# UNITED STATES PATENT AND TRADEMARK OFFICE

APPLICATION NO.	FILING DATE	FIRST NAMED INVENTOR	ATTORNEY DOCKET NO.	CONFIRMATION NO.
10/581,218	06/01/2006	Erik Houbolt	NL03 1455 US1	1649
24738	7590	07/13/2010	EXAMINER	
PHILIPS INTELLECTUAL PROPERTY & STANDARDS			PRONE, JASON D	
PO BOX 3001			ART UNIT	PAPER NUMBER
BRIARCLIFF MANOR, NY 10510-8001			3724	
MAIL DATE		DELIVERY MODE		
07/13/2010		PAPER

<b>Office Action Summary</b>	<b>Application No.</b>	<b>Applicant(s)</b>
	10/581,218	HOUBOLT ET AL.
	<b>Examiner</b>	<b>Art Unit</b>
	Jason Daniel Prone	3724

## **DETAILED ACTION**

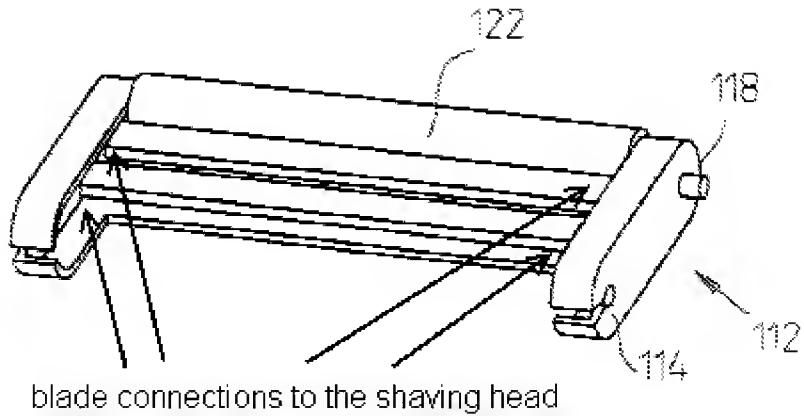
However, with regards to claims 1, 9, 10, 12, 13, and 16, Avidor fails to disclose the actively drivable device is a skin stretching device.

Zucker teaches it is old and well known in the art of shaving devices to incorporate 2 rollers that cooperate to stretch the skin (Column 5 lines 14-28). Therefore, it is well within ones technical grasp to have substituted roller 122 with a roller that would cooperate with guard 104 to stretch the skin. Therefore, it would have been obvious to one of ordinary skill in the art, at the time of the invention, to have replaced the roller of Avidor with a skin stretching roller, as taught by Zucker, because the substitution of one known element for another would have yielded predictable results and all claimed elements were known in the prior art and one skilled in the art could have combined the elements as claimed by known methods with no change in their respective function and the combination would have yielded predictable results.

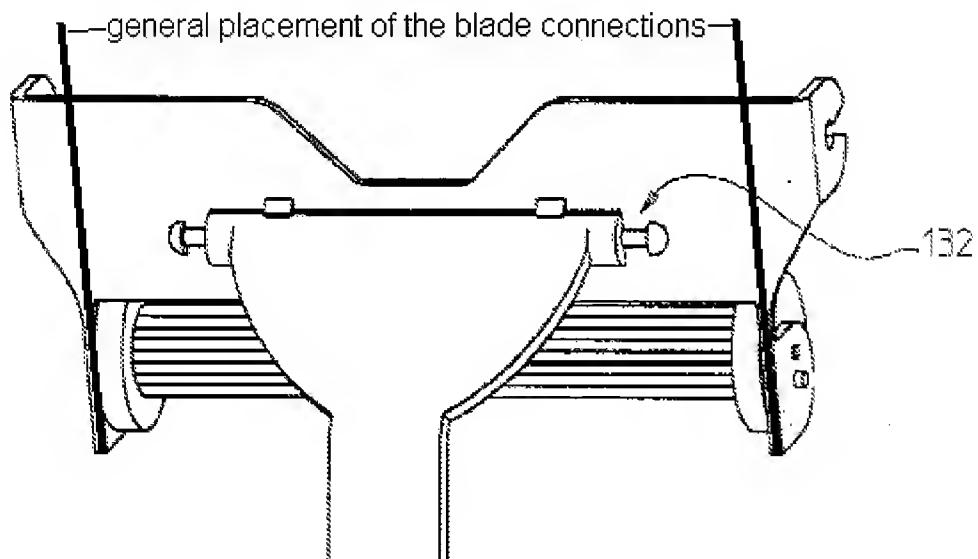
4. Claims 19 and 22 are rejected under 35 U.S.C. 103(a) as being unpatentable over Avidor in view of Zucker. See rejection above for the overlapping disclosure between claims 1 and 19. With regards to the newly added portions, Avidor discloses a shaving head (130 and 112), two cutting blades with cutting edges (Fig. 16), and the coupling and pivot axis is arranged between where the two cutting blades are coupled to the shaving head (see Figures below).

The blades are coupled to the outer edges of the shaving head.

The added dark lines represent roughly where these blade couplings are located to illustrate the pivot axis 132 is clearly between the where the two blades are coupled to the shaving head.
